# UNITED STATES PATENT AND TRADEMARK OFFICE

APPLICATION NO.	FILING DATE	FIRST NAMED INVENTOR	ATTORNEY DOCKET NO.	CONFIRMATION NO.
10/830,120	04/23/2004	Jung-hyun Lee	249/456	9015

**Office Action Summary**

Fig. 2

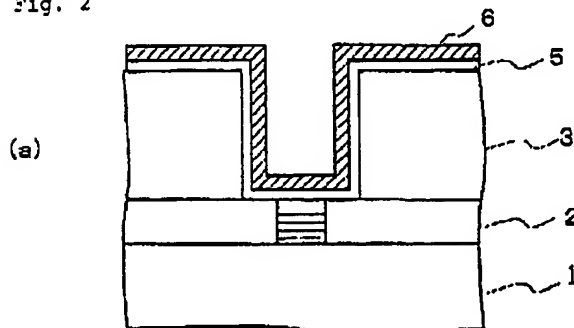
**Regarding claim 1**, Aoki et al. discloses a stack-type capacitor comprising:

a lower electrode; (Aoki et al., Fig. 2 ref #'s 5&6)

a dielectric layer formed on the lower electrode; (Aoki et al., Fig. 2 ref # 7)

a first metal layer having a cylindrical shape; and (Aoki et al., Fig. 2 ref # 5)

a second metal layer filled in the first metal layer. (Aoki et al., Fig. 2 ref # 6)

a lower electrode; (Aoki et al., Fig. 2 ref #'s 5&6)

a dielectric layer formed on the lower electrode; (Aoki et al, Fig. 2 ref # 7)  
and an upper electrode formed on the dielectric layer, (Aoki et al, Fig. 3 ref # 8)  
wherein the lower electrode includes:  
a first metal layer having a cylindrical shape; and (Aoki et al, Fig. 2 ref # 5)  
a second metal layer filled in the first metal layer. (Aoki et al, Fig. 2 ref # 6)

Fig. 3

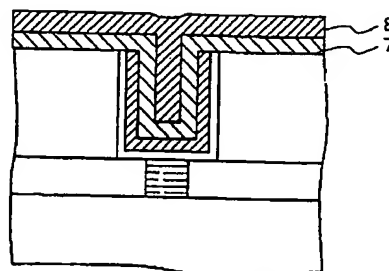
and an upper electrode formed on the dielectric layer, (Aoki et al., Fig. 3 ref # 8)
